TECHNICAL SERVICE BULLETIN

New CARQUEST Improved Connector and Pigtail for GM Fuel Pump Modules

TSB-1106-01_CQ

OLD DESIGN-TOP & SIDE VIEW

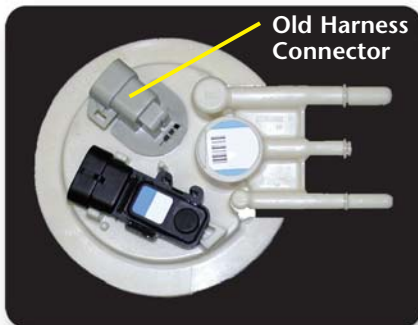
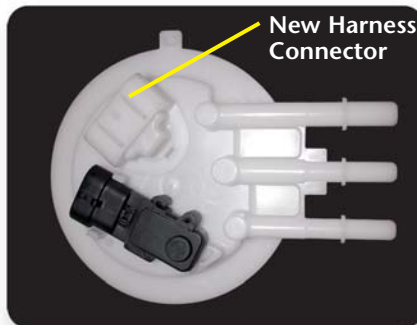
Many GM vehicles from 1988 to 2005 have electrical connectors on the fuel pump module that may become loose over time due to vibration, leading to faulty, high-resistance connections. The symptoms - burned or melted connectors and pins - lead to a voltage drop situation where low or no voltage can cause the module to stop pumping.

CARQUEST's latest fuel system solution provides a quick and reliable fix for burned or melted wiring harness connections on certain GM in-tank fuel pump applications. CARQUEST has replaced the faulty OEM design connector with a new OEM design that eliminates the burned or melted connectors and pins problem.

Fuel pump modules with the improved 4-pin connector require vehicle harness replacement. One of the five application-specific, color-coded vehicle wiring harnesses is included with every pump that uses the new connector.

New wiring harness included.
Refer to enclosed installation instructions.
